THE BABCOCK & WILCOX COMPANY
POWER GENERATION GROUP

Subj.
Auxiliary Feedwater Setpoints

November 15, 1978

High/Low SFZCS Control

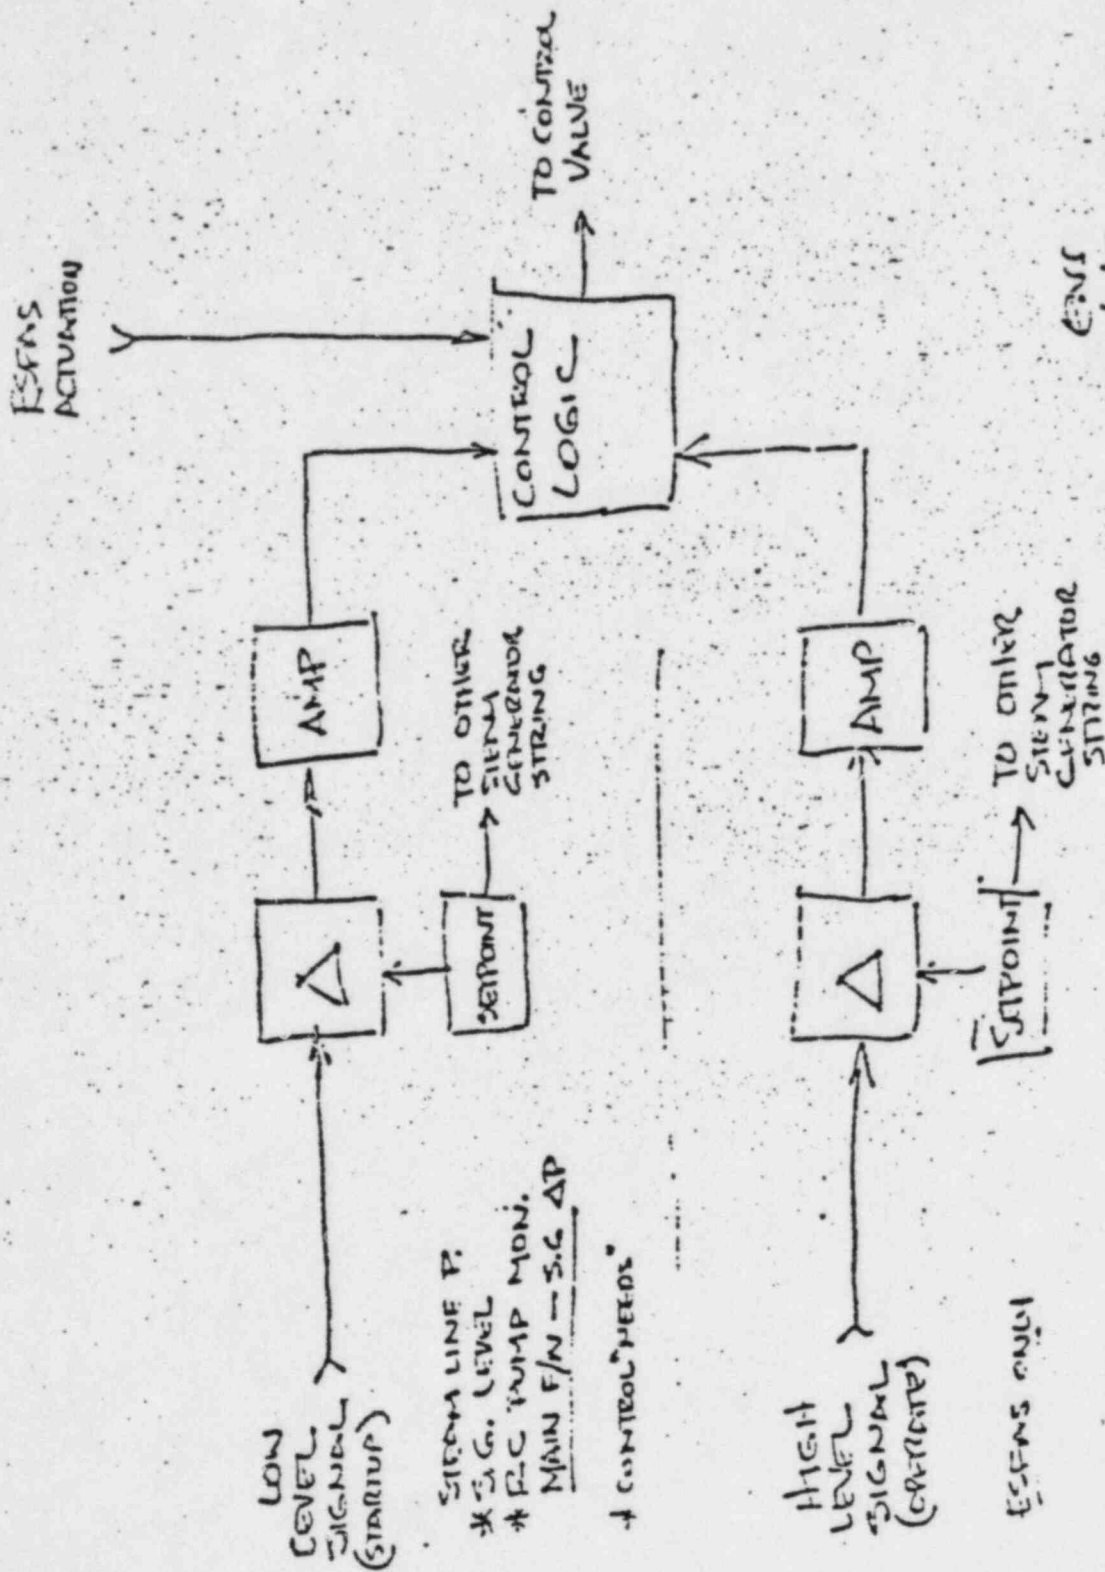
ESFAS/SFRAB MOD. IS PROBABLY
THE BEST FIX IN THAT FIELD
CHANGES WOULD BE LESS EXPENSIVE &
IMPACT ON ECCS WOULD BE
OF LESS RISK. THAT IS, ONE WOULD
AT LEAST GET A 10-H⁺ LEVEL DURING
POST-LOCA CONDITIONS. → IS A LEVEL
CONTROL FOLLOWING ESFAS ACTUATION
MANDATORY? LLL.

ESFAS
↓
APW ACT.
↓
NO LEVEL
CONTROL
↓
OPERATOR
MAY INTER.
TO TERMINATE
AFW FLOW
